# Glencoe Elementary

## GUARDIAN 275® SYSTEM SPECIFICATIONS

THREE (3) SINGLE SLOPE SKYLIGHTS  
WIDTH: 6'-2"  
LENGTH: 7'-8"  
SLOPE: 4.76°  
BAYS: 1 UPSLOPE, 2 LENGTHWISE

CONTRACTOR IS RESPONSIBLE TO CHECK AND COORDINATE THIS SUBMITTAL WITH THE REQUIREMENTS OF THE WORK AND TO VERIFY ALL QUANTITIES, MATERIALS, FIELD MEASUREMENTS AND FIELD CONSTRUCTION CRITERIA RELATED THERETO. REVIEW IS ONLY FOR CONFORMANCE WITH THE DESIGN CONCEPT OF THE WORK AND COMPLIANCE WITH THE INFORMATION GIVEN IN THE CONTRACT DOCUMENTS. NO DEVIATIONS FROM THE CONTRACT DOCUMENTS ARE INCLUDED IN THIS REVIEW UNLESS CALLED TO ATTENTION OF ARCHITECT AND RESPONDED TO IN WRITING BY ARCHITECT.		NOT REVIEWED	
		REJECTED	
		REVISE AND RESUBMIT	
		FINAL REVIEW EXCEPTIONS NOTED	
	DATE: 07/06/2022	FINAL REVIEW NO EXCEPTIONS NOTED	
	BY: Elyssa Adams	REVIEWED ONLY FOR LOADS TO STRUCTURE	
	SUBMITTAL #: 08 45 23-6	SUBMIT SPECIFIC ITEM

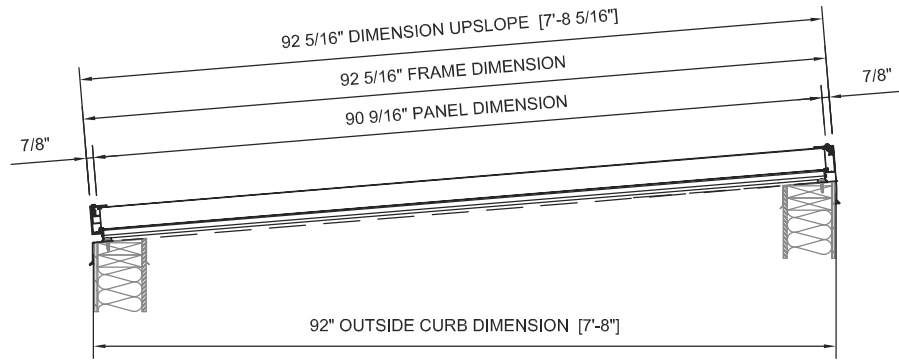
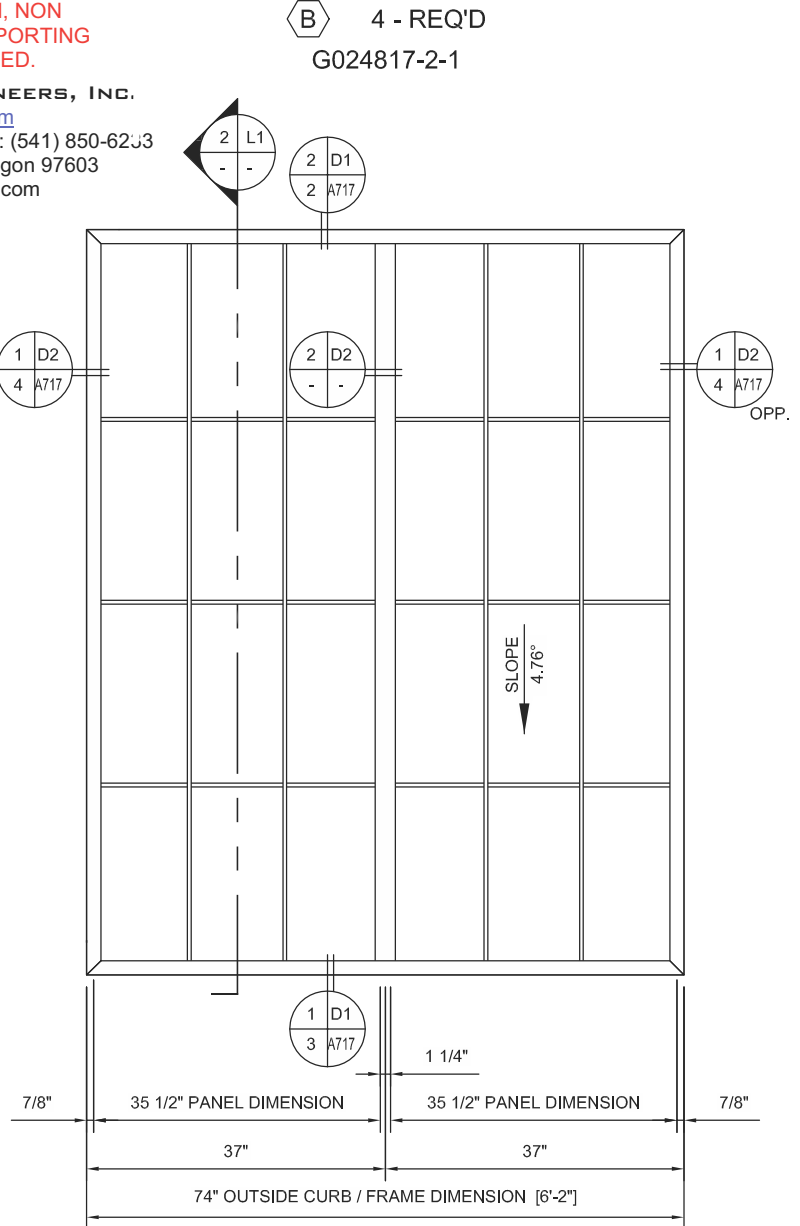
Contractor to field verify all dimensions.  
-OHPD

HEET D1

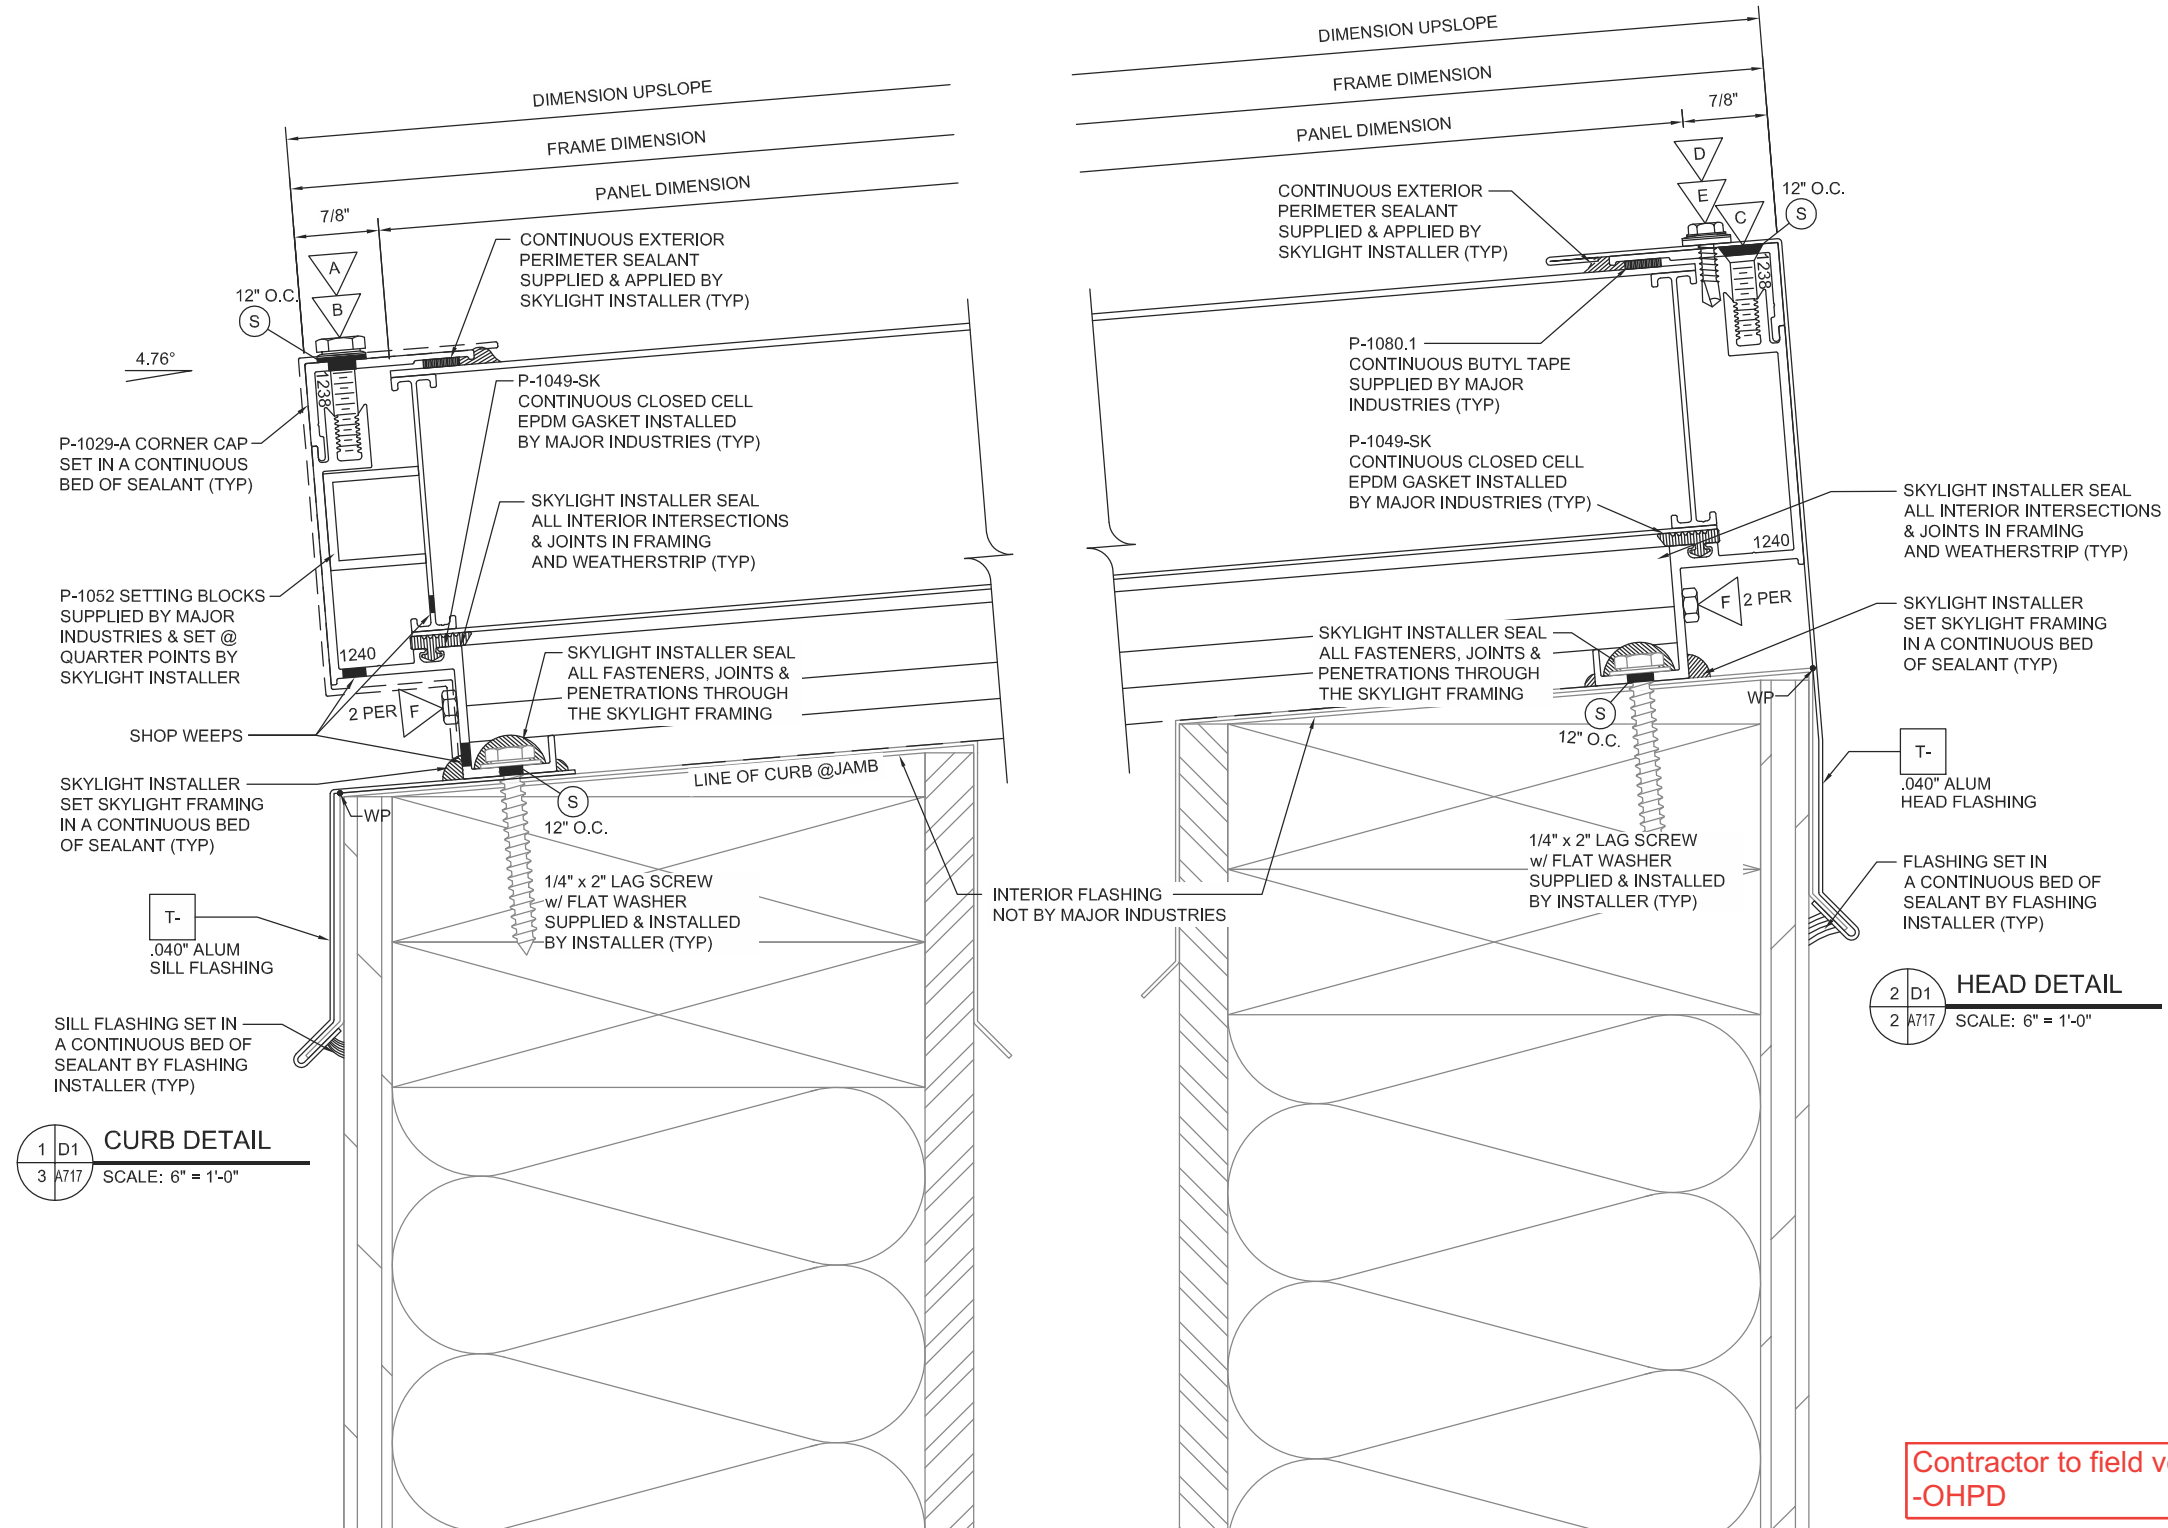
STRUCTURAL MEMBERS OF THIS  
SKYLIGHT SYSTEM ONLY INCLUDED  
IN THIS REVIEW/DESIGN, NON  
STRUCTURAL AND SUPPORTING  
ELEMENTS NOT INCULDED.

Contractor to field verify all dimensions.  
-OHPD
